ASSESSMENT REPORT

EASTERN CREEK BUSINESS HUB, ROOTY HILL SSD 5175 MOD 2

Figure 4 Proposed Concept Plan

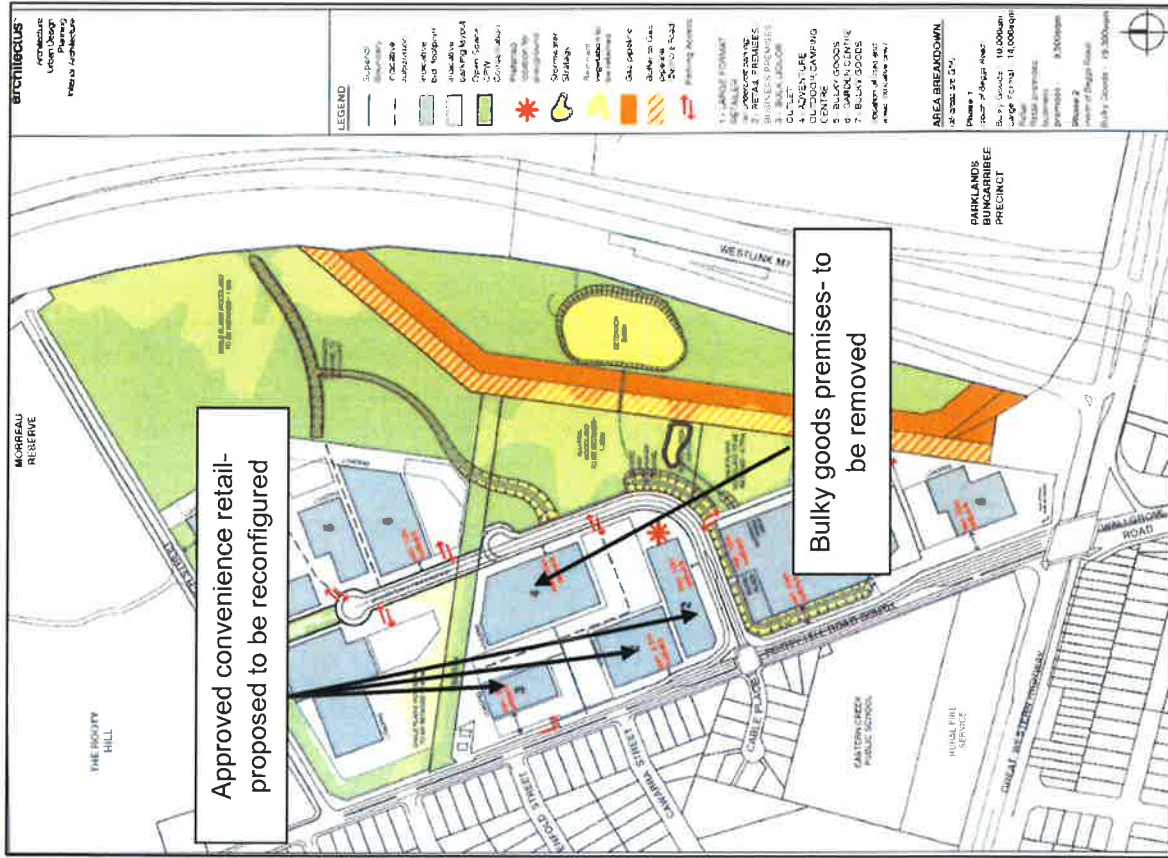
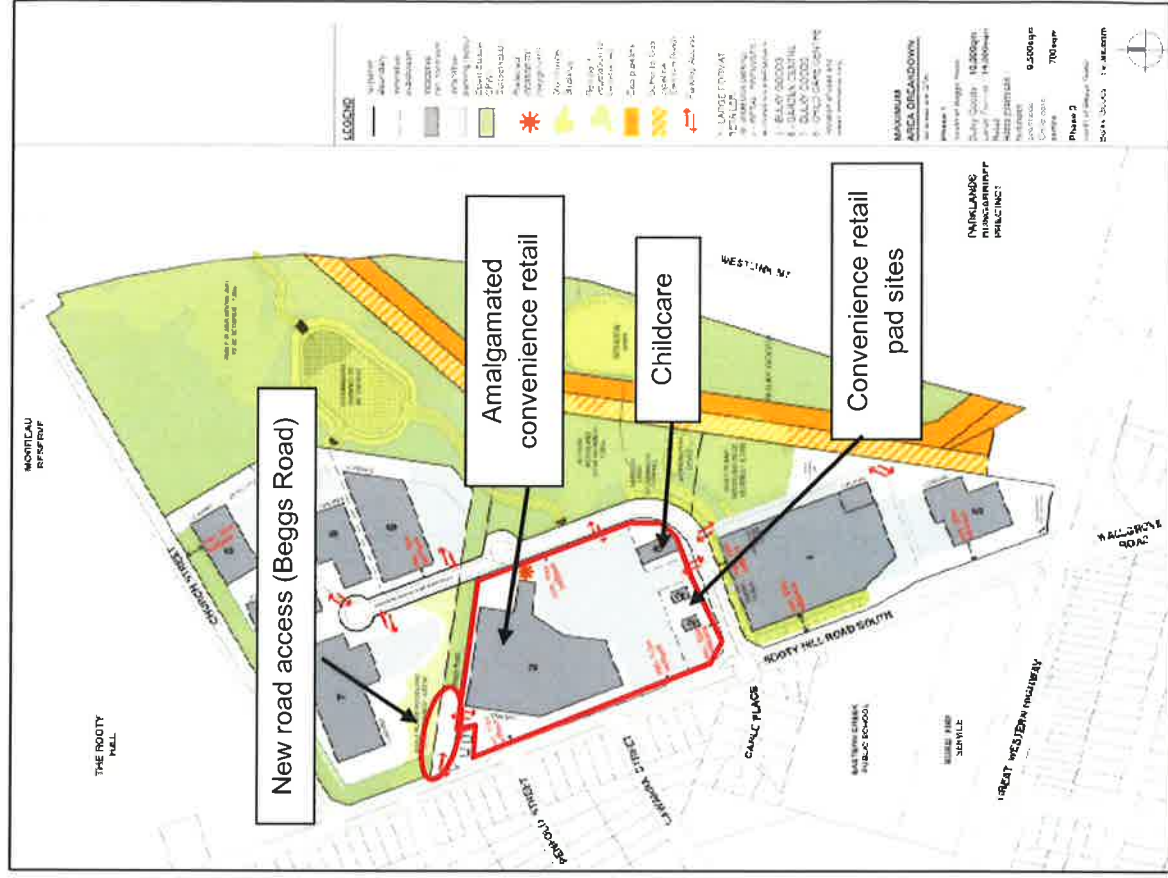
- deletion of one bulky goods outlet
- consolidate three convenience retail outlets into a single building envelope, plus two small pad (stand alone) sites
- the provision of a new access road within the existing Beggs Road reserve to provide access to a loading dock
- the provision of a child care centre site (with an additional floor space of 700 m²)
- relocation of the children's playground to the eastern side of the retail centre
- approval for additional permitted uses, including a 'medical centre' and 'indoor recreation facility' (gymnasium) within Lot 2 of the site
- amendments to the Landscape Masterplan to reflect the above changes
- updated Urban Design Guidelines to reflect the proposed built form modifications.

The approved and proposed layouts are shown in **Figures 3 and 4** below.

Figure 5 Loading dock adjacent to Rooty Hill Road South

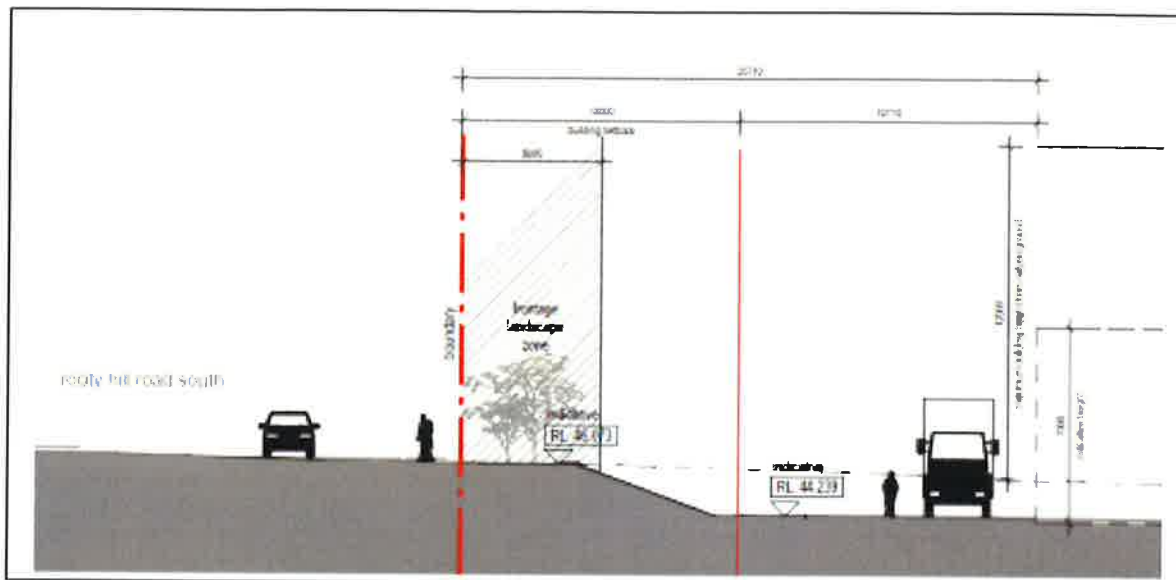
Council raised concern about the potential visual impacts of the new building envelope, particularly the proposal to incorporate the loading dock and service area on the Rooty Hill Road South façade. As such, Council suggested further information be provided about the treatment of the façade and the incorporation of further controls in the Urban Design Guidelines, including:

- building frontages to address the streets
- 40% of the building façade to be activated
- appropriate screening and landscaping to Rooty Hill Road South.

In response, the Applicant updated the Urban Design Guidelines to incorporate Council's suggestions.

The Department has considered the potential visual impacts of the modification and considers that subject to appropriate detailed design at the future DA stage, the appearance of the building and loading dock when viewed from Rooty Hill Road South, would be acceptable as:

The Department considers the proposed changes would not result in unacceptable visual impacts and that appropriate controls have been incorporated into the Urban Design Guidelines to ensure future development presents a high quality visual appearance.
